FINAL NON TIME CRITICAL REMOVAL ACTION WORK PLAN UNEXPLODED ORDANCE 16
(UXO 16) ADJACENT TO CAYO LA CHIVA ATLANTIC FLEET WEAPONS TRAINING AREA
FORMER VIEQUES NAVAL TRAINING RANGE VIEQUES ISLAND PUERTO RICO

**UXO 16 Adjacent to Cayo la Chiva
Non-Time-Critical Removal Action
Work Plan**

**Final Responses to EPA Comments on the
Draft UXO 16 Adjacent to Cayo la Chiva
Non-Time-Critical Removal Action Work Plan
Dated March 2016**

Final Responses to PREQB's Comments on the
Draft UXO 16 Adjacent to Cayo la Chiva
Non-Time-Critical Removal Action Work Plan
Dated March 2016

Figure 1-3
Underwater MEC/MPPEH Exclusion Zones
 Work Plan for NTCRA UXO 16 Adjacent to Cayo La Chiva
 Atlantic Fleet Weapons Training Area - Vieques
 Vieques, Puerto Rico

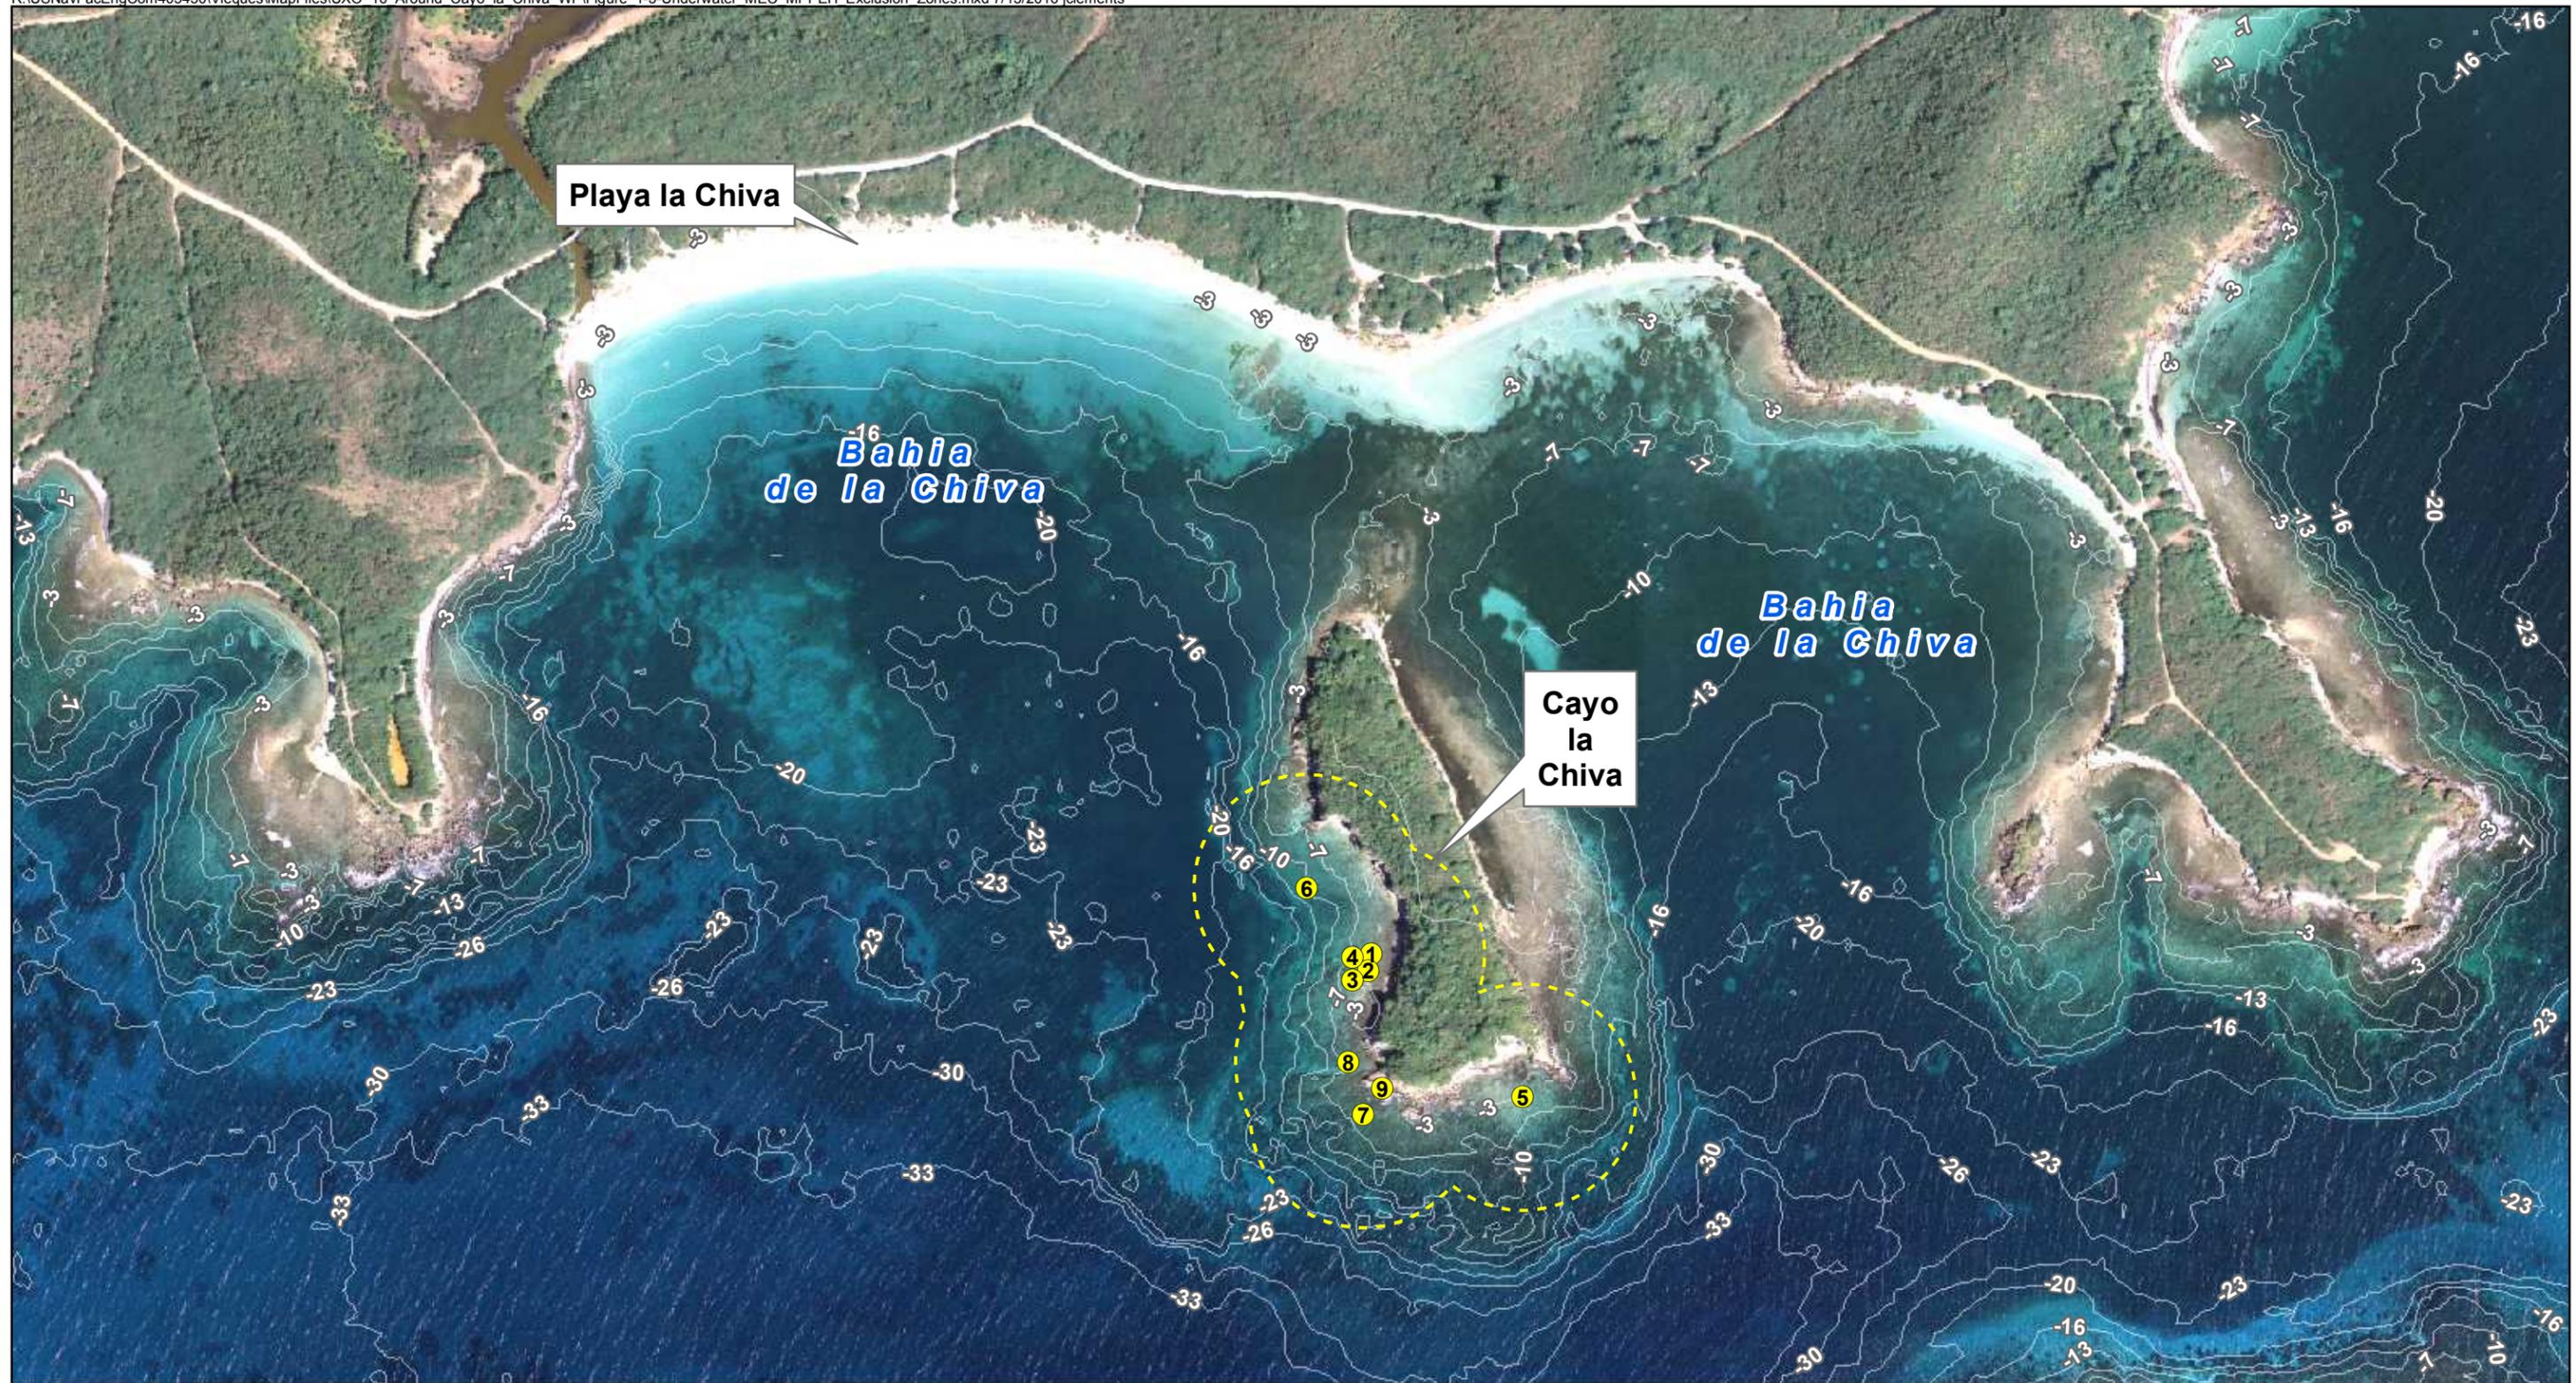
3. **Section 2.1 Technical Approach, last paragraph, Page 2-1:** The text mentions the Exclusion Zone (EZ), but then refers to the project’s explosive safety submission plan for any additional details. To make the Draft UXO 16 NTCRA WP more self-contained, add a paragraph describing the extent of the EZ in relation to the locations of the MEC/MPPEH items. It is also suggested (if feasible/possible) to show the approximate extent of the future EZ around Cayo la Chiva on Figure 1.3.

Navy Response: Consistent with all previous NTCRA work plans on Vieques, the text will refer to the ESS completed as a separate document since the information is not pertinent to achieving the NTCRA objectives. However, Figure 1-3 has been revised to indicate the exclusion zone for each munitions item.
